10.2 Turbine Generator

The information in this section of the reference ABWR DCD, including all subsections, tables and figures, is incorporated by reference with the following departures and supplements.

**Figure 10.2-1 Turbine Stop Valve Closure Characteristic**

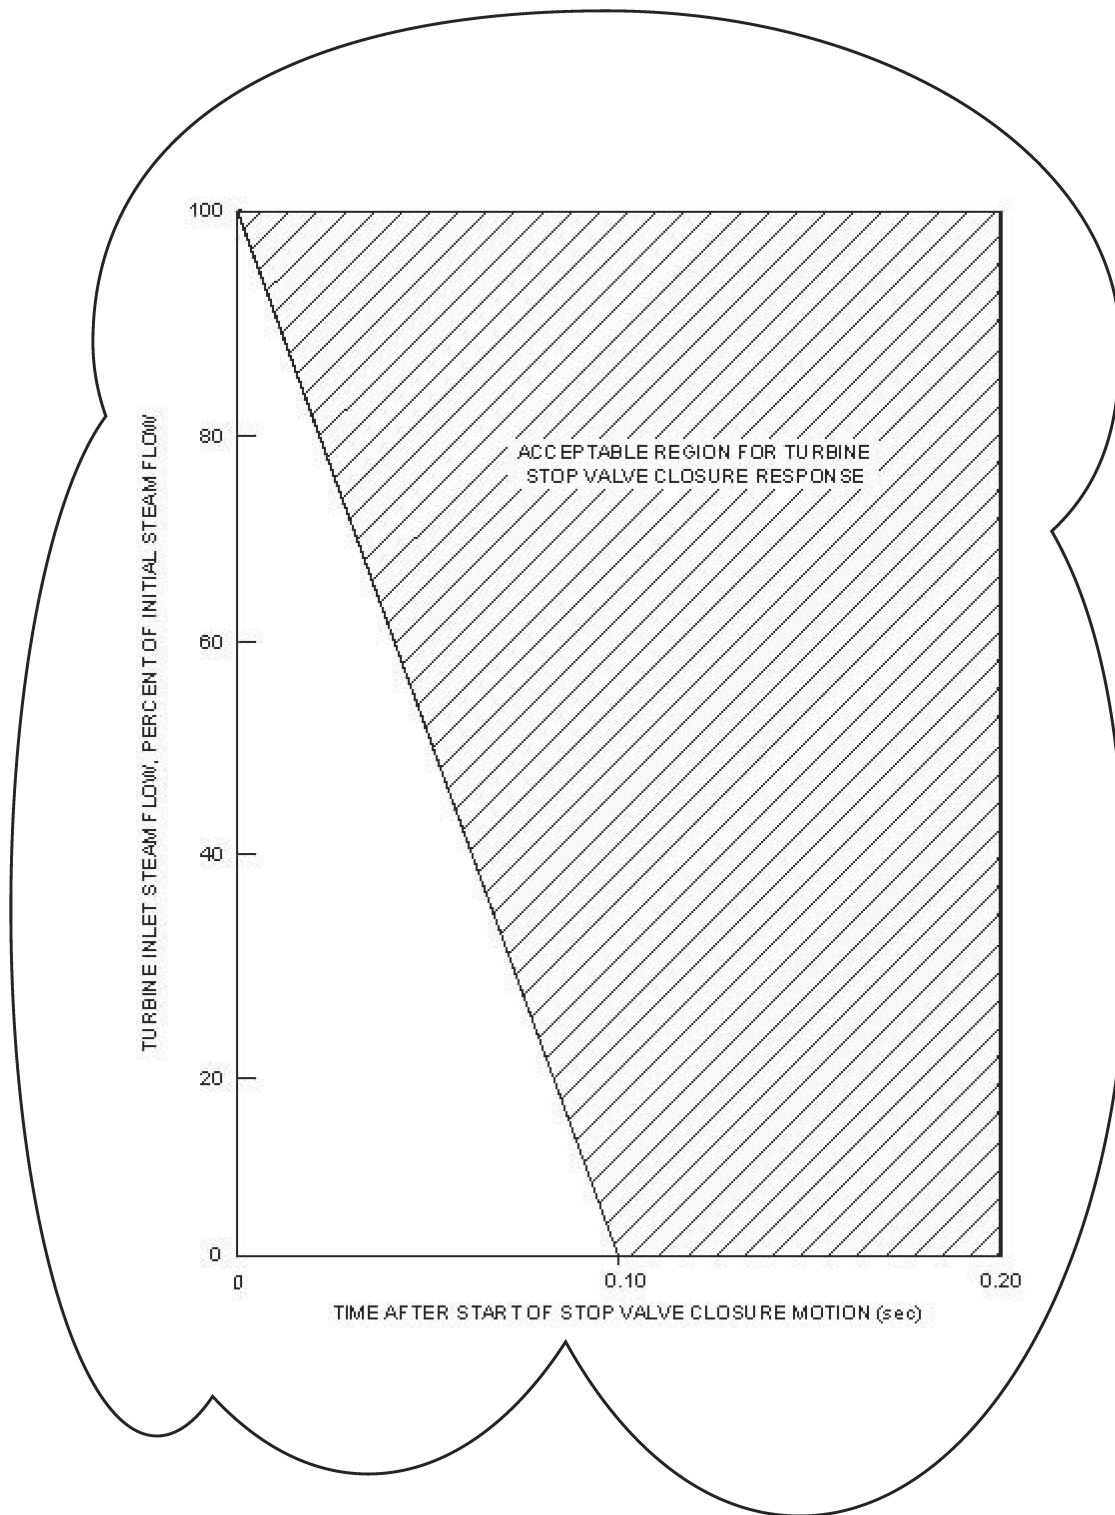
STD DEP Admin (Figure 10.2-1)

Figure 10.2-4 Generator Hydrogen and CO₂ System

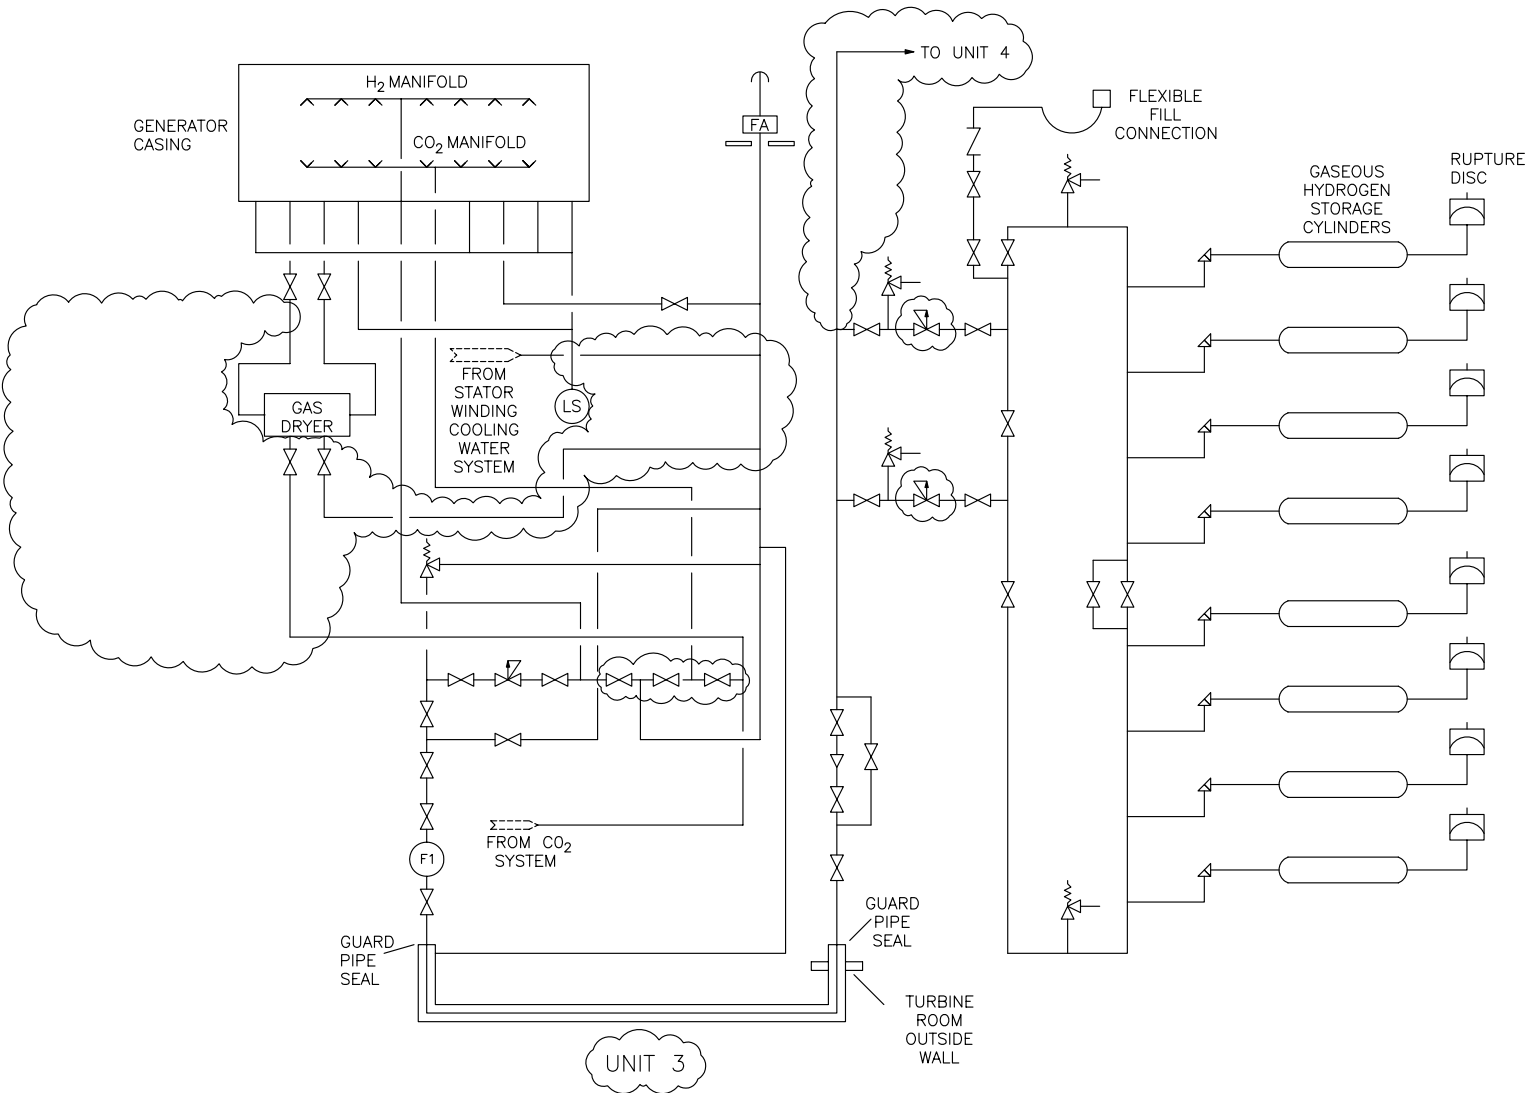
STP DEP 1.1-2 (Figure 10.2-4)

STP DEP 10.2-1 (Figure 10.2-4)

Bulk Hydrogen System—*The bulk hydrogen and CO₂ system is illustrated on Figure 10.2-4. The hydrogen system is designed to provide the necessary flow and pressure at the main generator for purging carbon dioxide during startup and supply makeup hydrogen for generator leakage during normal operation.*

Figure 10.2-5 Turbine Overspeed Trip System Functional Diagram

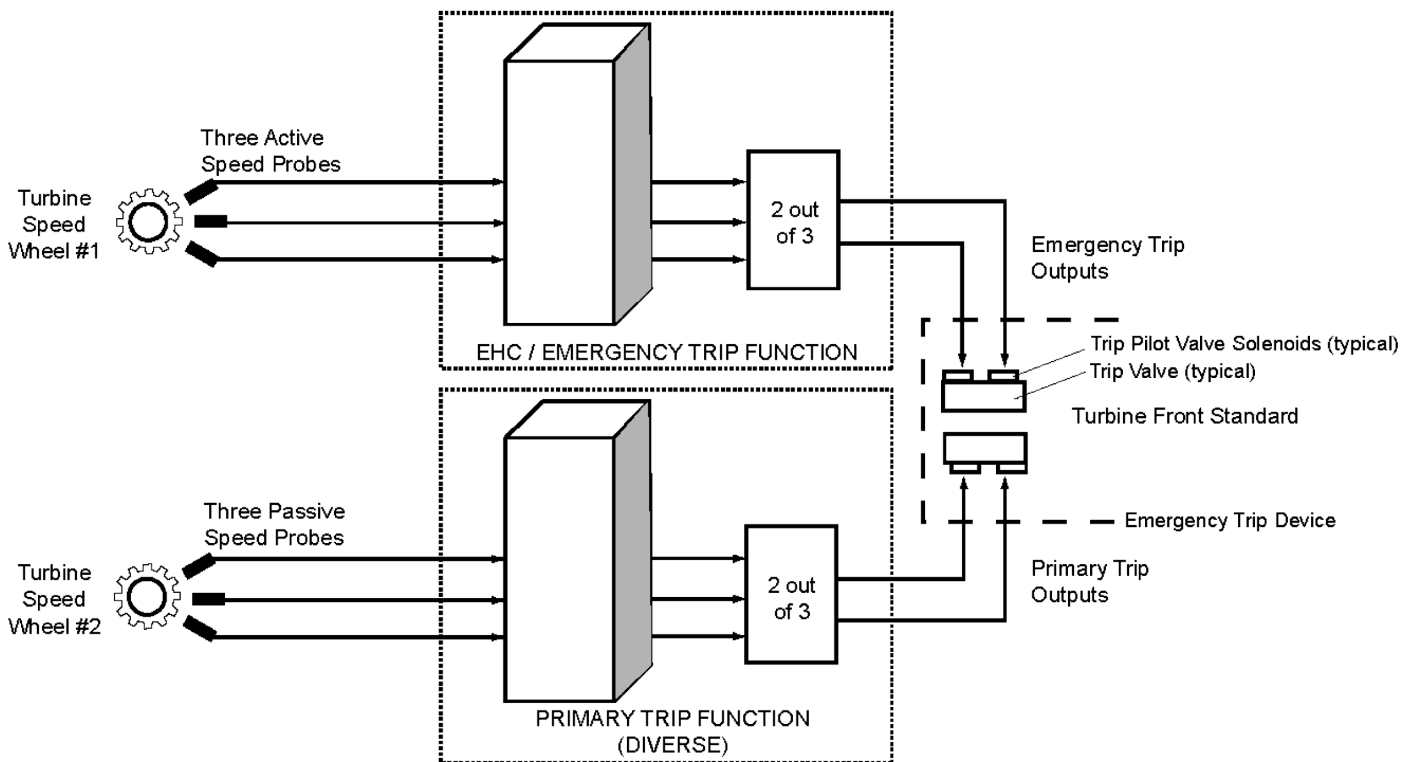
The primary trip function is independent and diverse from the emergency trip function as explained below (refer to Figure 10.2-5, Turbine Overspeed Trip System Functional Diagram). Two-out-of-three logic is employed in both the primary and emergency overspeed trip circuitry. Each trip function can de-energize its associated trip pilot valve solenoids of the electro-hydraulic Emergency Trip Device (ETD). The ETD is composed of two independent trip valves, each with two normally energized fail-safe solenoids. For each trip valve, each trip pilot valve solenoid is powered from a separate power source. The solenoids de-energize in response to detection of an overspeed condition by the turbine speed control logic. De-energization of both trip pilot valve solenoids is necessary to cause the spool in their respective trip valve to reposition, which depressurizes the emergency trip fluid system, rapidly closing all steam inlet valves and indirectly closing the steam extraction nonreturn valves. Accordingly, the repositioning of only one of the two trip valves is necessary to trip the main turbine. A single electrical component failure does not compromise trip protection, and does not result in a turbine trip. Each trip valve in the ETD is testable while the turbine is in operation.

and emergency overspeed trip functions also use separate speed wheels (refer to Figure 10.2-5). Each speed signal for the primary trip function is compared to a speed setpoint of approximately 110% of rated speed, and produces trip signals arranged in two-out-of-three logics, to de-energize both trip pilot valve solenoids of one of the two trip valves of the ETD. Both trip pilot valve solenoids must be de-energized to trip the associated trip valve. The ETD has two redundant trip valves. Tripping of either redundant trip valve will drain the emergency trip fluid, resulting in a turbine trip.
